John Bernier, MCIP, RPP
Development Review, Central
110 Laurier Avenue West. Ottawa, ON
613.580.2424 ext 21576
John.Bernier@ottawa.ca

Re: Site Plan Control Application
File Number: D07-12-22-0094– 78 Rosemount Avenue

78 ROSEMOUNT AVE.

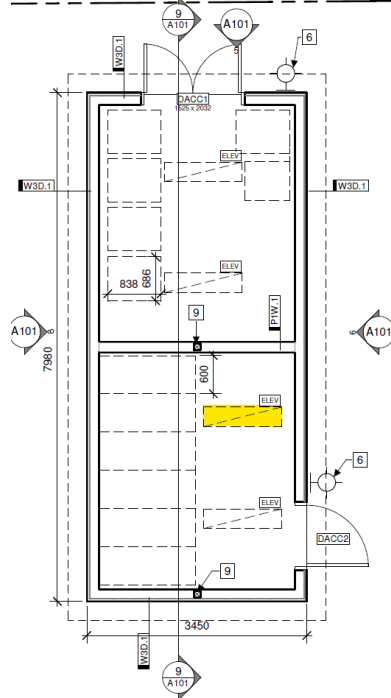
4. The dashed box in the plan is a light fixture (above).

Please see image below for clarification:

1 SITE PLAN
 A100 1:100

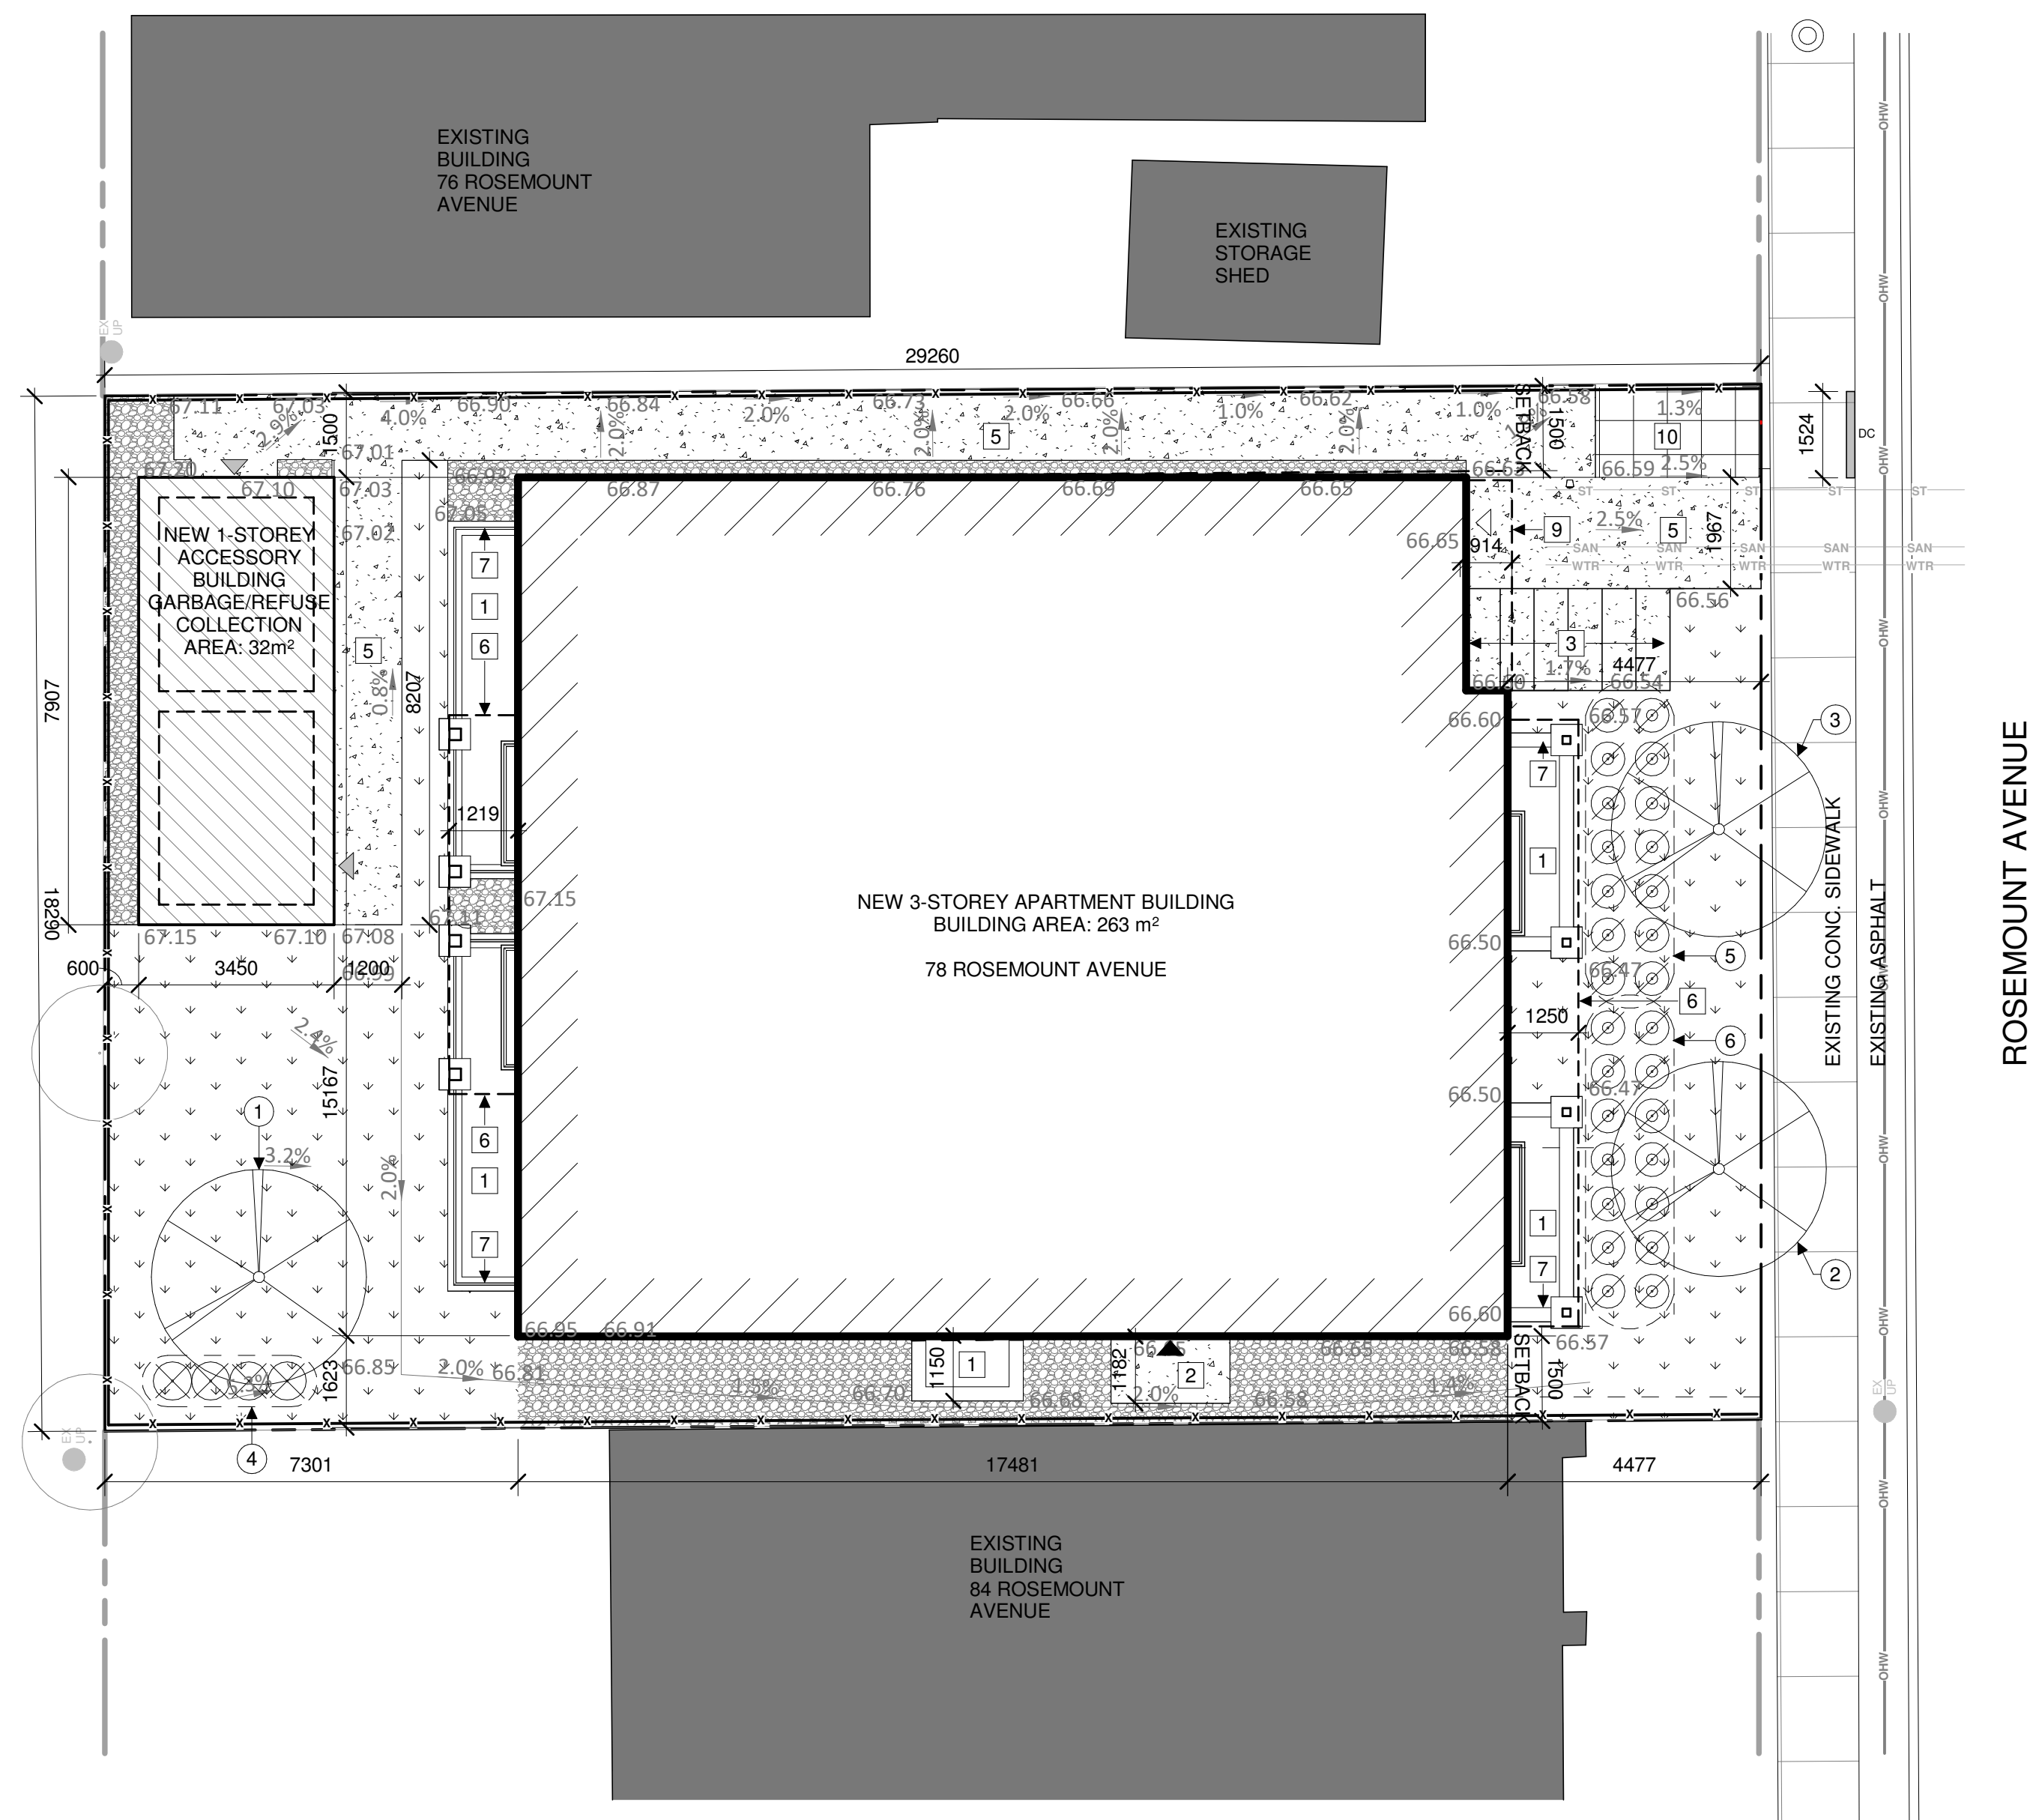
5. Noted. Please see attached A100.

42. The reference survey is included on A100.

52.1.a. Noted. A survey of the medium voltage hydro wire location was completed. The proposed building location has been moved back so that it does not fall within the "restricted zone" surrounding overhead lines.

2 ACCESSORY BUILDING FLOOR PLAN

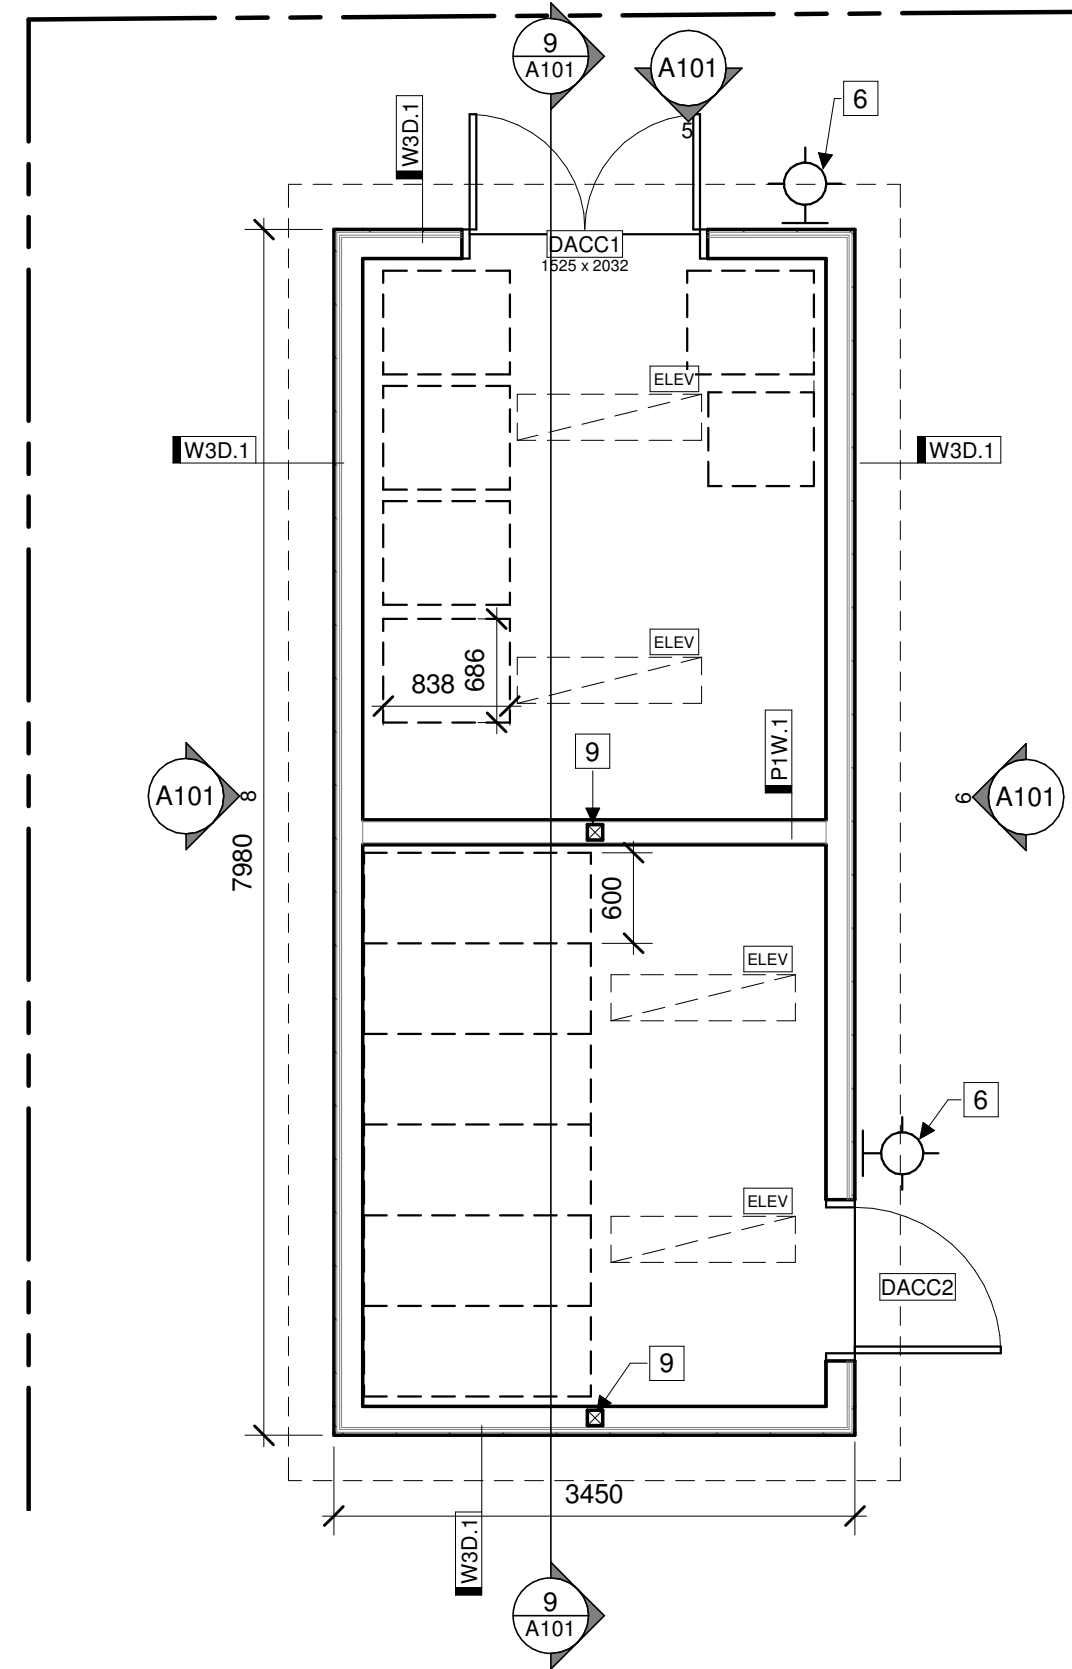
44. Noted, a set of double doors has been indicated on revised drawing A101.

45. Noted, (assuming there was a typo and this is meant to indicate 1 organics bin, rather than 11). The allocated area for these bins is indicated in plan on drawing 2/A101.
